KILDARE COUNTY COUNCIL

PLANNING DEPARTMENT

Development proposed by, on behalf of, or in partnership with Local Authority

Residential Development at Greenfields, Maynooth

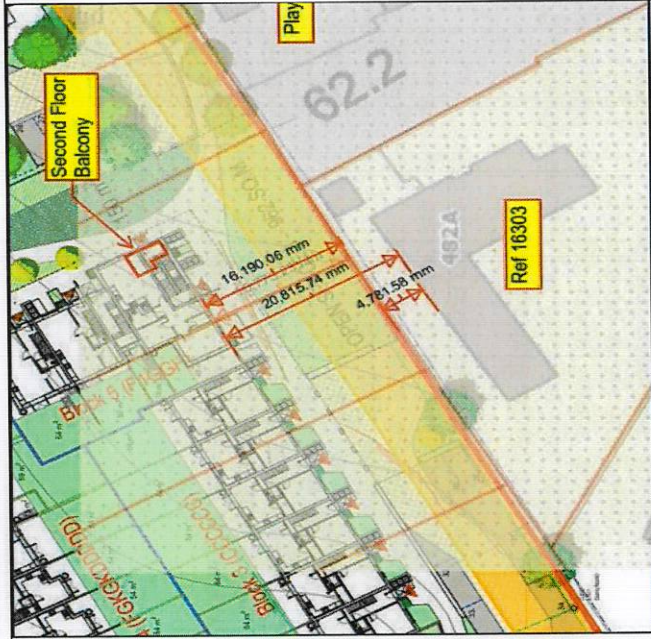
living area. Our ground floor windows are potentially closer to the first-floor window levels of the new development than the ground floor windows.)

We would suggest the following amendments

- Our strong preference is for all blocks be two stories in keeping with surrounding houses.
- That current proximity to our property is assessed and not moved any closer in any amendments.
- Failing the above, the Block 5 south facing second floor bedroom window should be omitted. The second-floor landing window should be fitted with permanently obscured glazing. A rooflight (i.e. Velux window) could be fitted at the landing. The second floor balcony proposed on Block 5 should be omitted entirely or be screened to 1.8m high on the south facing side. This additional height may however not resolve overlooking for the crèche playground.

6. House and crèche location on site plan:
See extract of site drawing attached with our house and the crèche superimposed. Measurements shown in red are estimates based on scaling on the plans – these need to be accurately assessed, particularly in respect of our property which is not parallel to the boundary wall. A window with a view into my living area is located at the point where my property is closest to the boundary wall.

5. We will ensure there are no bedroom / habitable room windows in the existing dwelling or creche overlooked. Any windows on stairwells which overlook will be of obscure glazing. Any balconies overlooking will be screened off from overlooking.
